1.2 Darling Harbour promenade and setbacks to podium and tower

1.3 Tower setback and wind assessment

Figure 1 Waterfront setback diagram (amended)

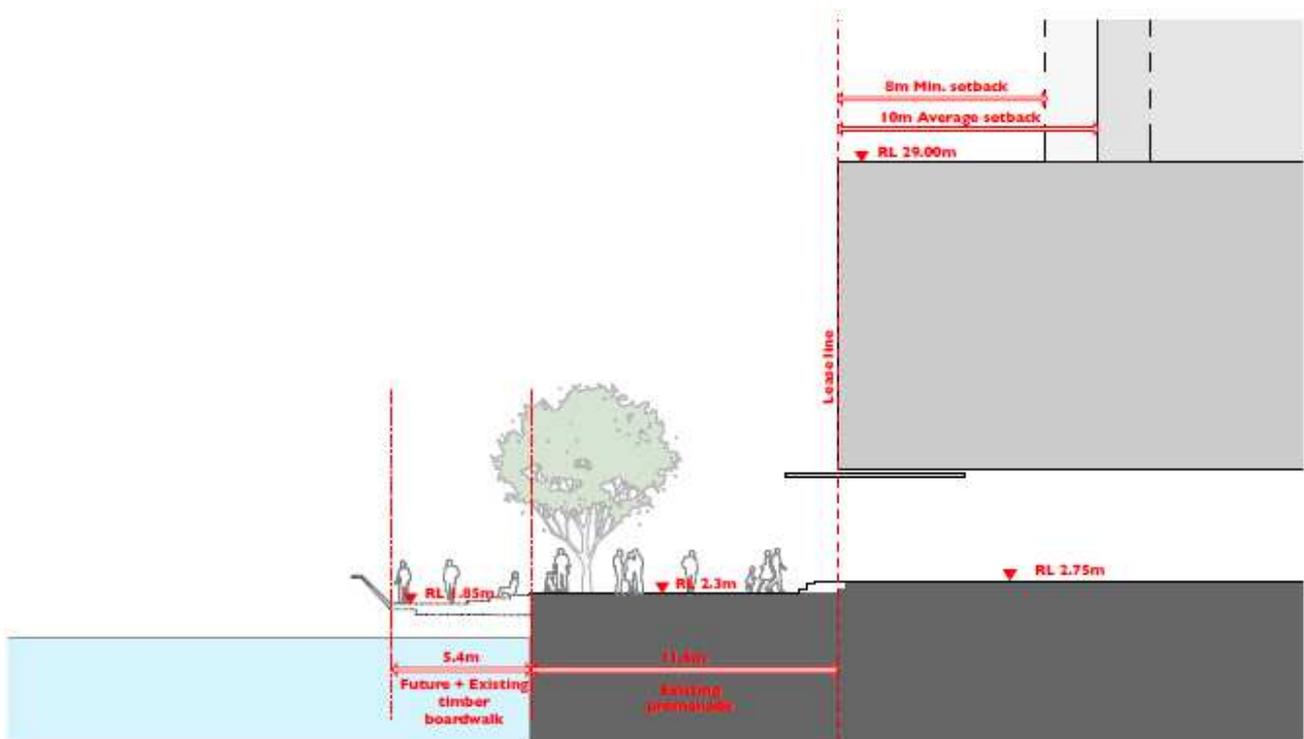
The Commission requested clarification of the width of the promenade and building setbacks to it. An amended setback diagram has been prepared (Figure 47 from the Design Report, see **Figure 1**) that clarifies that the width of the existing and proposed promenade is 11.6m, as measured from the lease line. This does not include any existing areas of boardwalk.

It is noted that the boardwalk (shown on the diagram) does not exist along the entire length of the promenade. It was the Department’s preference that any works to the boardwalk not be included in the application and be considered separately, if required. Accordingly, the proposal does not involve any works to the boardwalk.

The podium is proposed to be built to the lease line (zero setback) whilst the tower is to have a minimum 8m setback with an average 10m setback to the lease line. It is highly likely that there will be additional pedestrian circulation at ground level within the subject site to the east of the lease line, to provide circulation within the retail/ dining/ entertainment uses proposed in this location as per the section detail below.

Figure 2 Promenade setback

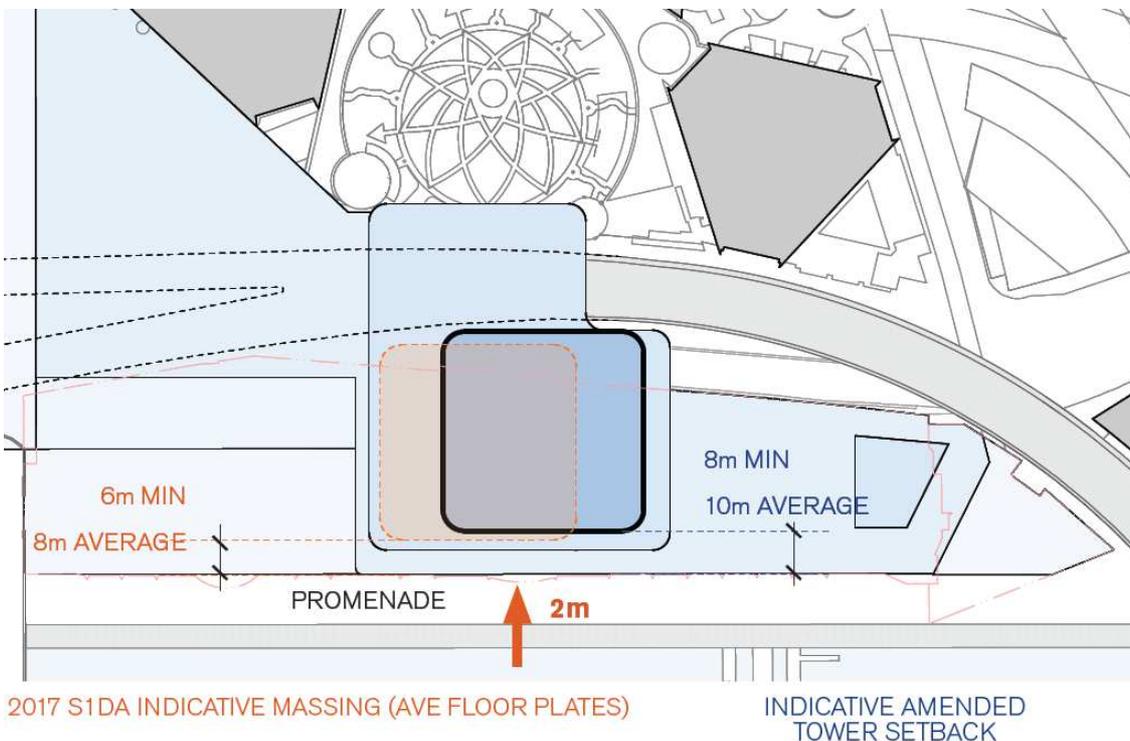
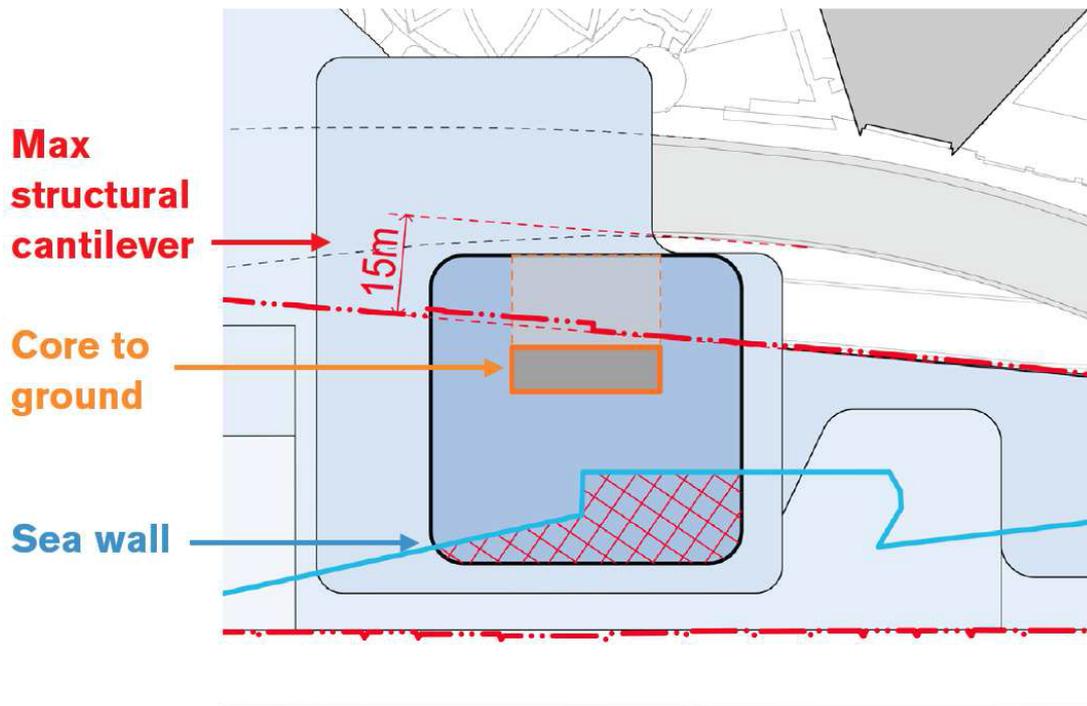
The application proposes an average weighted setback to the tower above the podium of 10 metres, with a minimum setback of 8 metres. We understand that Council has asked for a single 10m tower setback. The weighted average and minimum setback approach affords important flexibility to allow for a range of diverse architectural design and building articulation responses through the competitive design process.

It is noted that the minimum 8m and weighted-average 10m setbacks proposed are 2 metres greater than the setbacks required for towers located elsewhere in Central Sydney under the Sydney DCP 2012 (however, noting they do not apply to Cockle Bay or this project).

The location and positioning of the tower form on this site is constrained by the proximity to the Western Distributor to the east and the sea wall to the west, and accordingly any increase in the setback as suggested by Council would constrain the ability to deliver a suitable depth of floorplate for commercial uses and would reduce the capacity to incorporate articulation in the building façade.

Having regard to the above, we consider that the setback as proposed (and as supported by DPE) is appropriate in the context of this site having regard to the technical analysis and urban design studies undertaken to date, and in reference to the established controls for other towers throughout the Sydney CBD.

Figure 4 Movement and circulation diagram

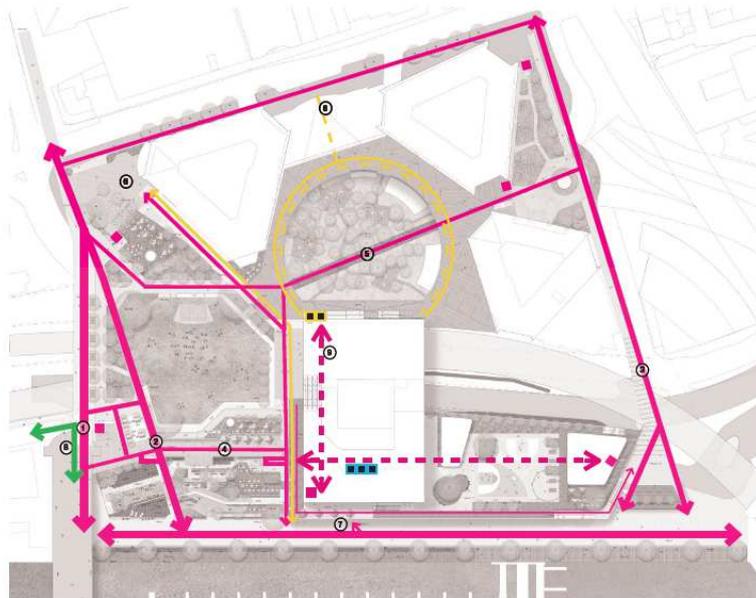
Movement and circulation across the site will be available by 24 hours accessible open space, stairs and public lifts located at the north and south ends of Cockle Bay. These public lifts are complemented by retail and tenant lifts in the centre of the site. Additional public lifts facilitate access from Sussex Street at the Market Street and DrUITT Street interfaces with Darling Park. A movement diagram is provided below.

Figure 5 Indicative Podium Internal Layout

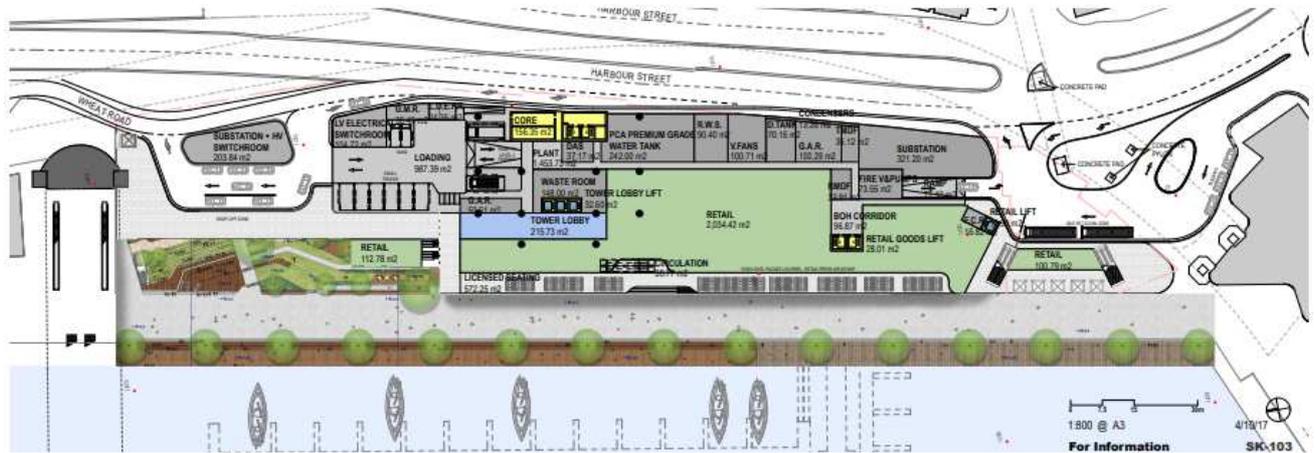
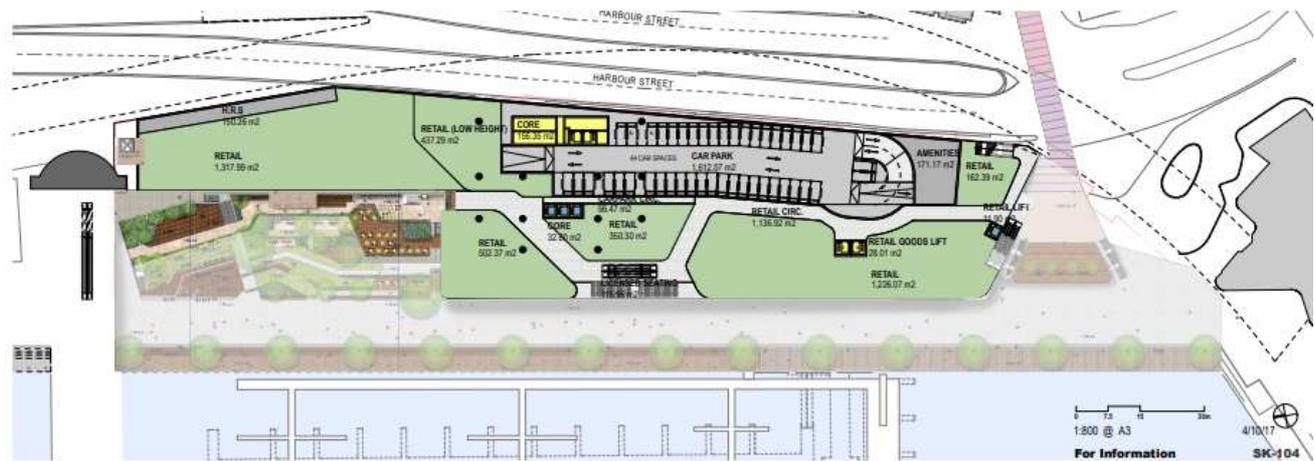
The podium is proposed to be activated by retail across three levels, sleeving back of house services and car parking. The indicative design and layout of the podium is shown at **Figure 4** below.
